Planning Board Meeting

October 17, 2023

ASSISTANT PLANNERS REPORT

ASSISTANT PLANNER REPORT

| AT: | ASSESSORS' PLAT 52 LOT 20A | |

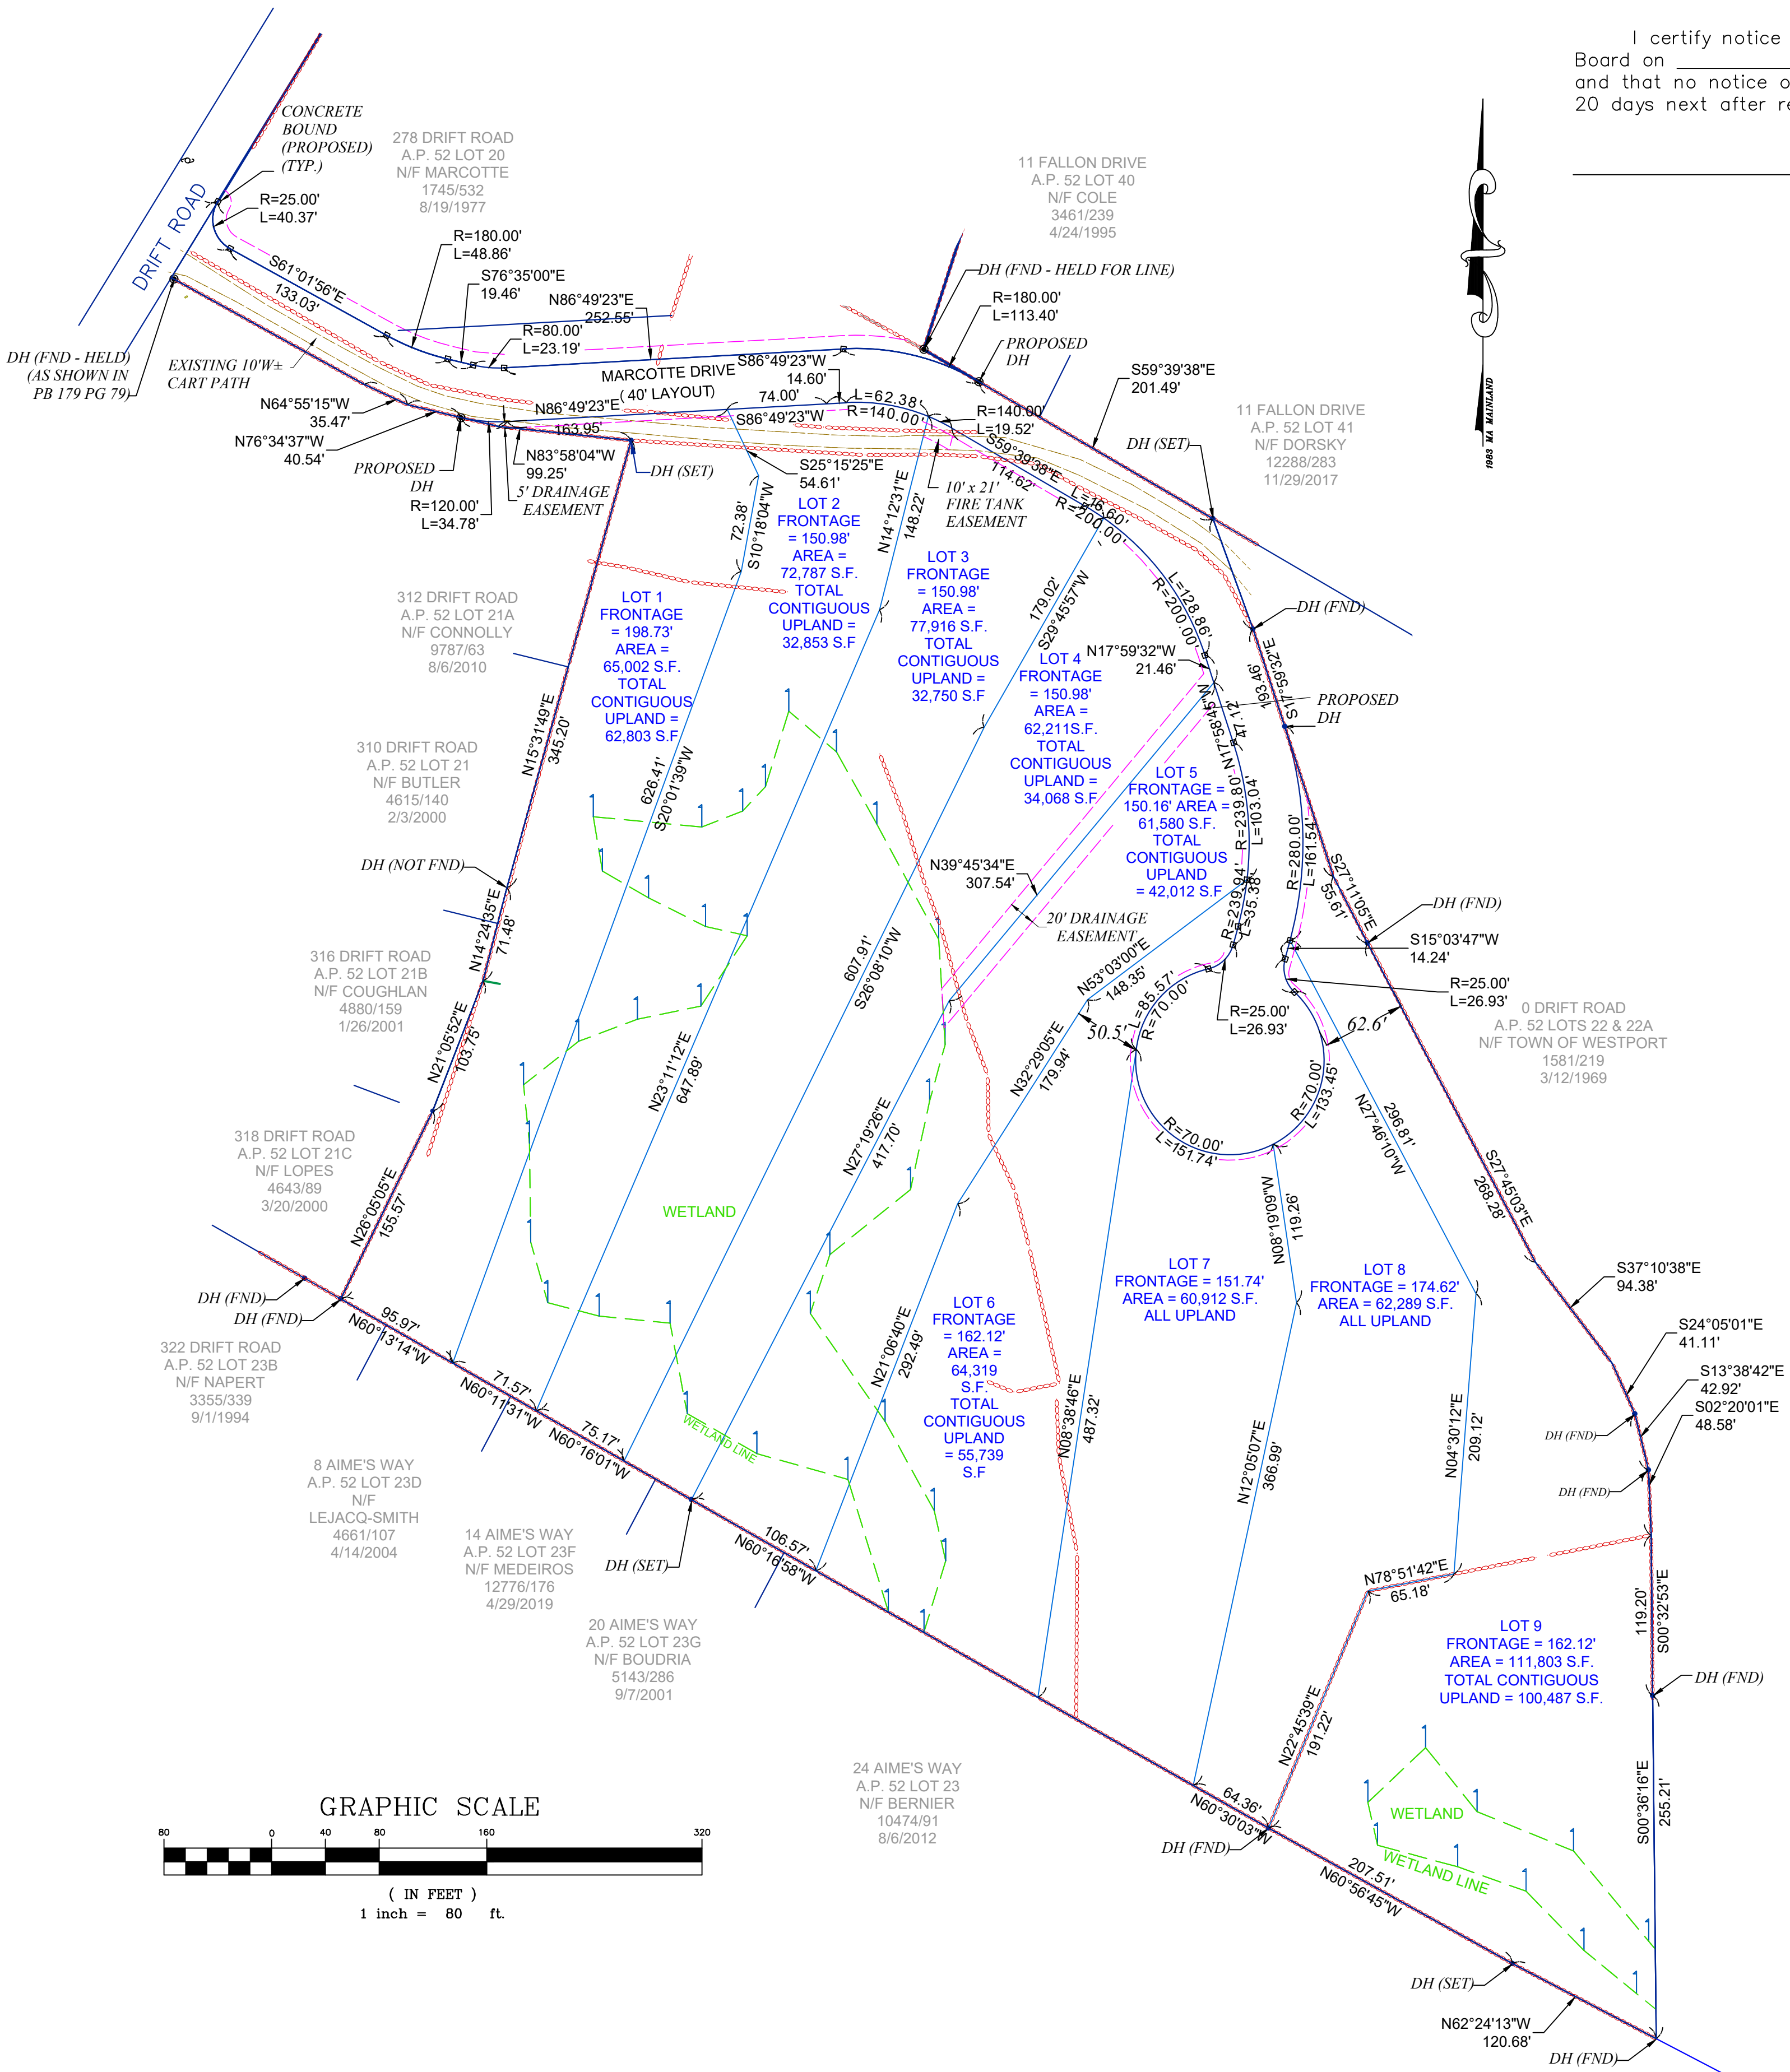
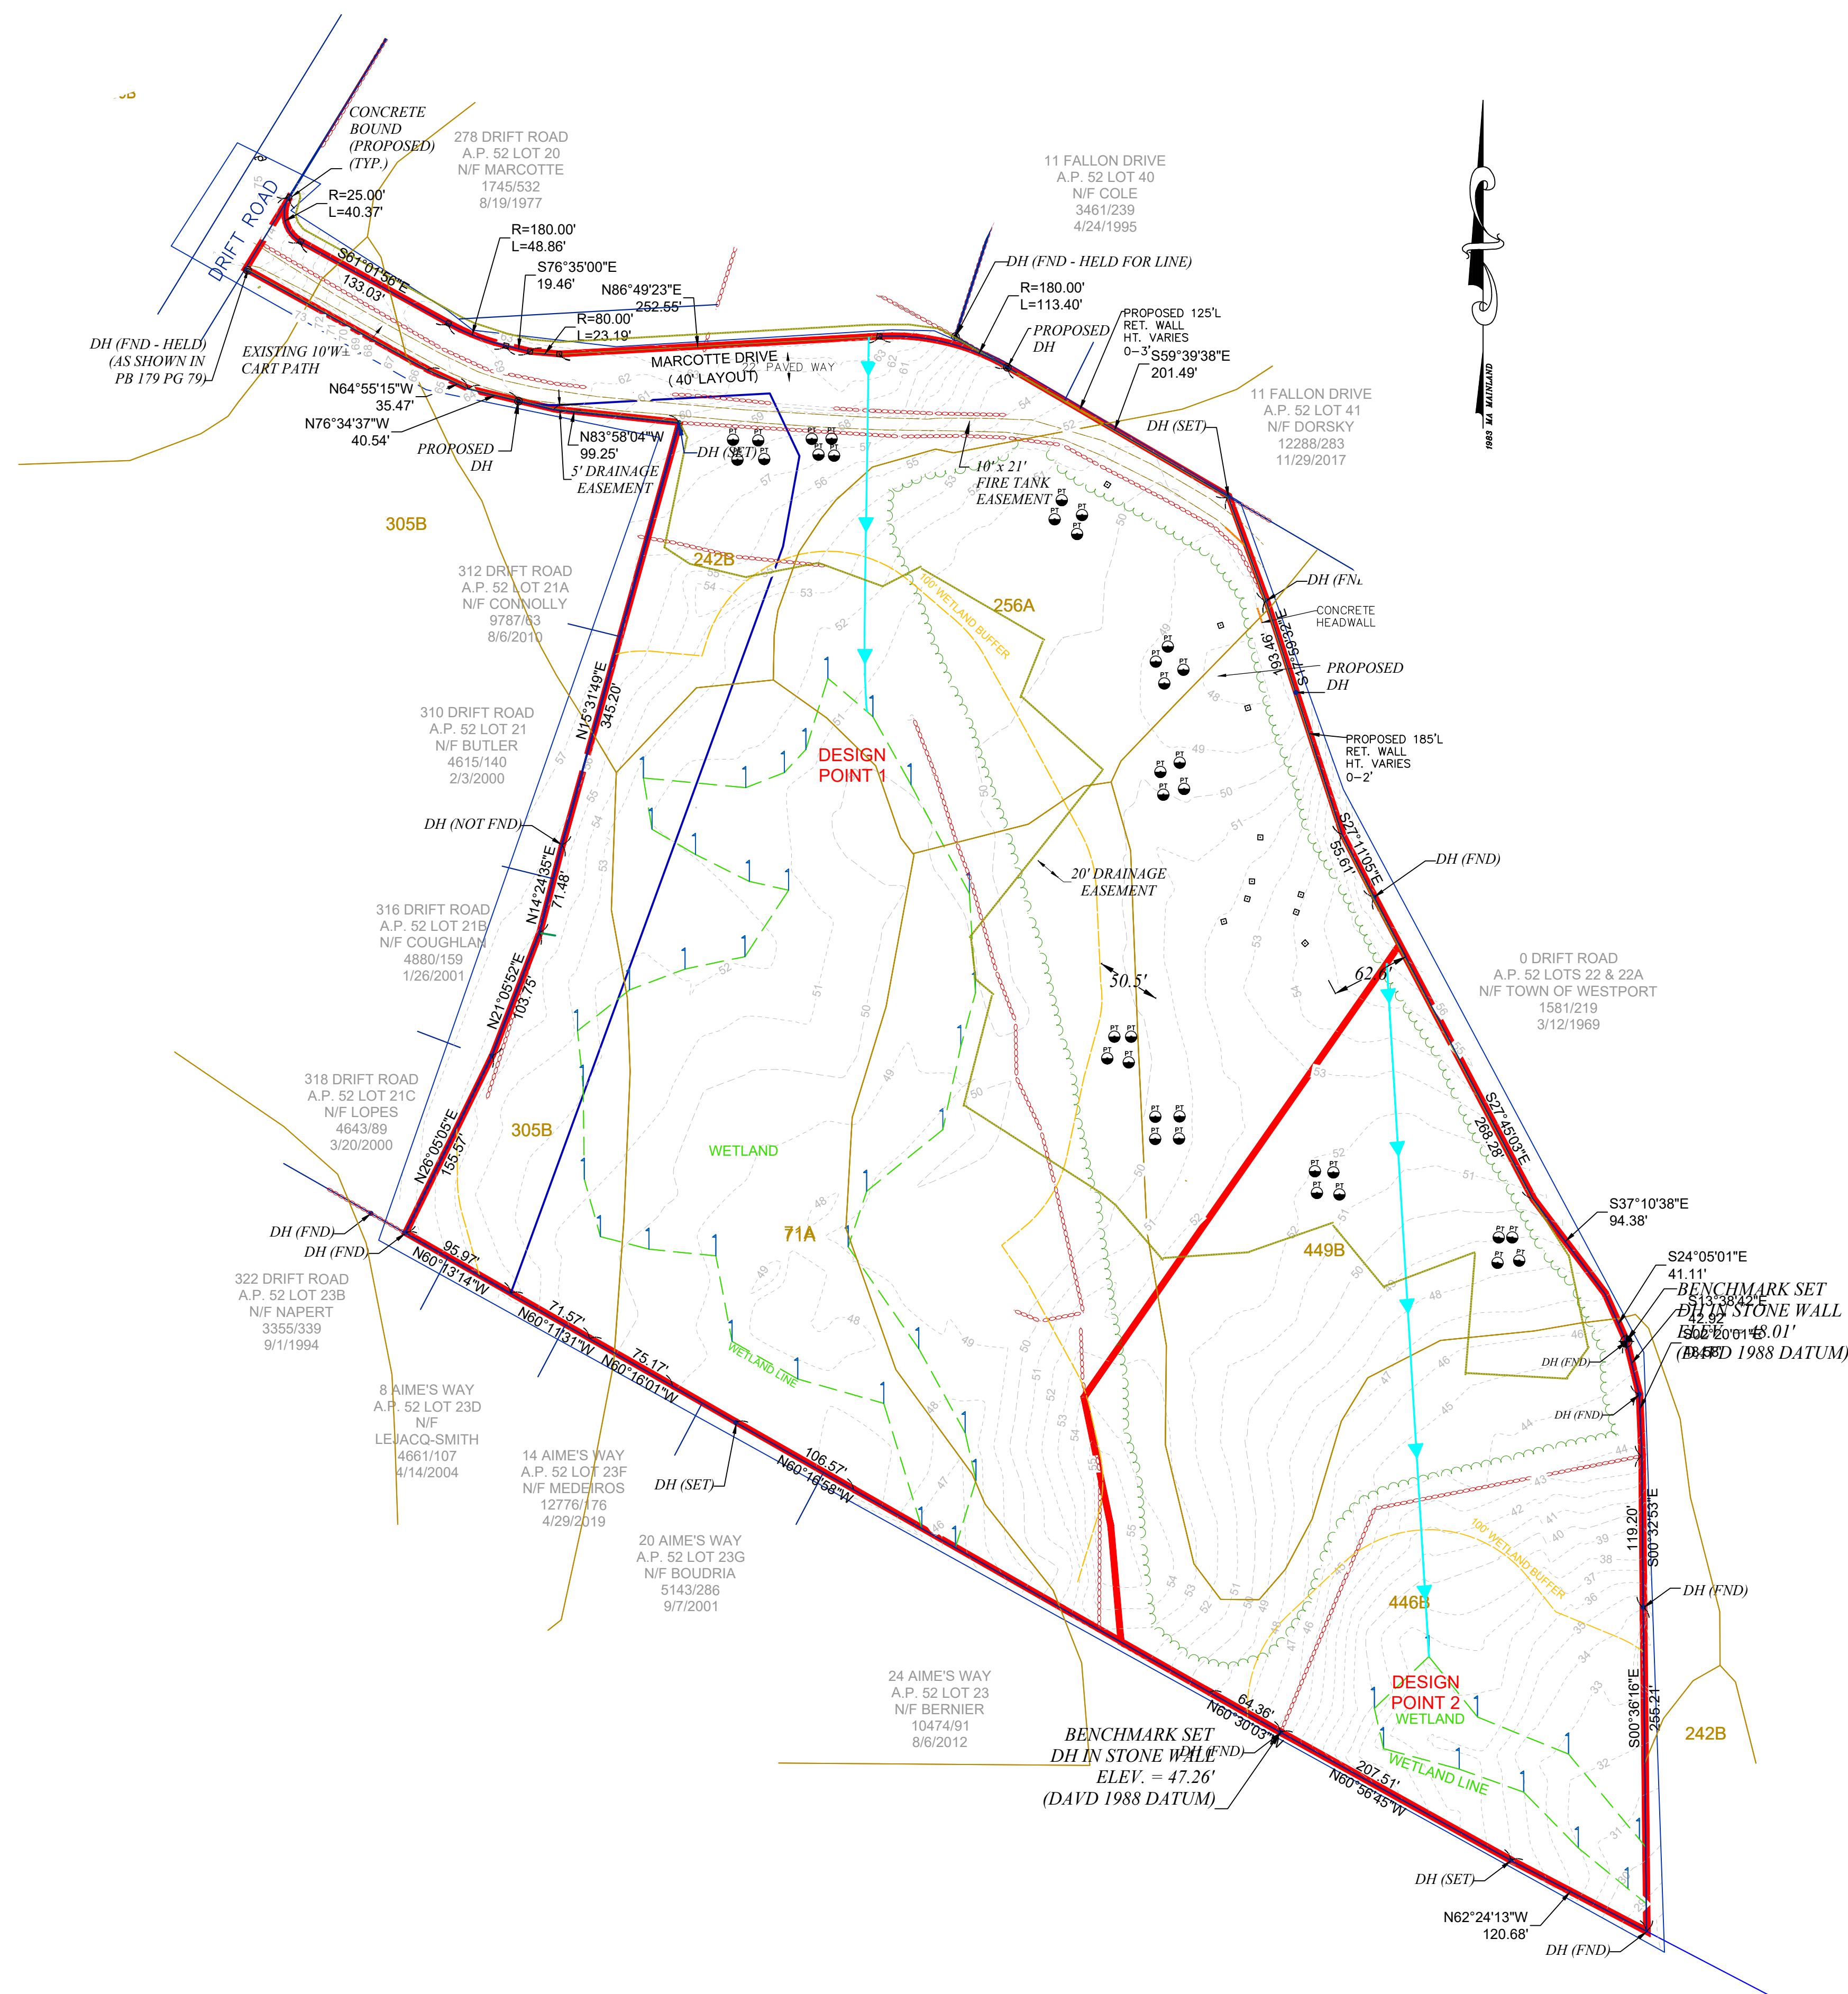
- **Subdivision name and title "Definitive Plan" are missing from plan set. Plan sheets are not named, only numbered (ex. Existing conditions, proposed conditions, street layout, grading plan)**

- **Plans are not stamped and signed by a P.L.S. however, a Designer's Certificate was submitted with the application. The Designer's Certificate is for Gregory Nicholas, and the Plans were drawn by Matthew Pike.**

- **existing easement within the subdivision to the abutting land to the back owned by the Town of Westport is not included on the plan set.**
- e. Location, names, and present widths of adjacent streets.

- **Width of Drift Road is not marked on plan set.**
- f. Width and location of existing and proposed roadways and sidewalks within and adjacent to the subdivision.

- **Width of Drift Road not marked on plan, no sidewalks are proposed or existing in proposed development or along Drift Road.**
 - **Proposed roadway mentions a 1' berm in the narrative, however it is not shown on the plan.**

- a. **All 9 lots are numbered and in sequence and meet the minimum frontage requirements with over 150 ft. of frontage; have adequate area (>60,000 s.f.) and uplands (> 30,000 s.f.)**

- **Applicant is requesting a waiver from elevations referring to Mean Sea Level in lieu of NAVD 1988 datum.**
- n. Suitable space in the lower right hand corner of the plan to record the action of the Board and the signatures of the members of the Board. (see Form P in Appendix). When the applicants elect to request conditional approval, there shall also be a notation below such space to the effect that the approval of the
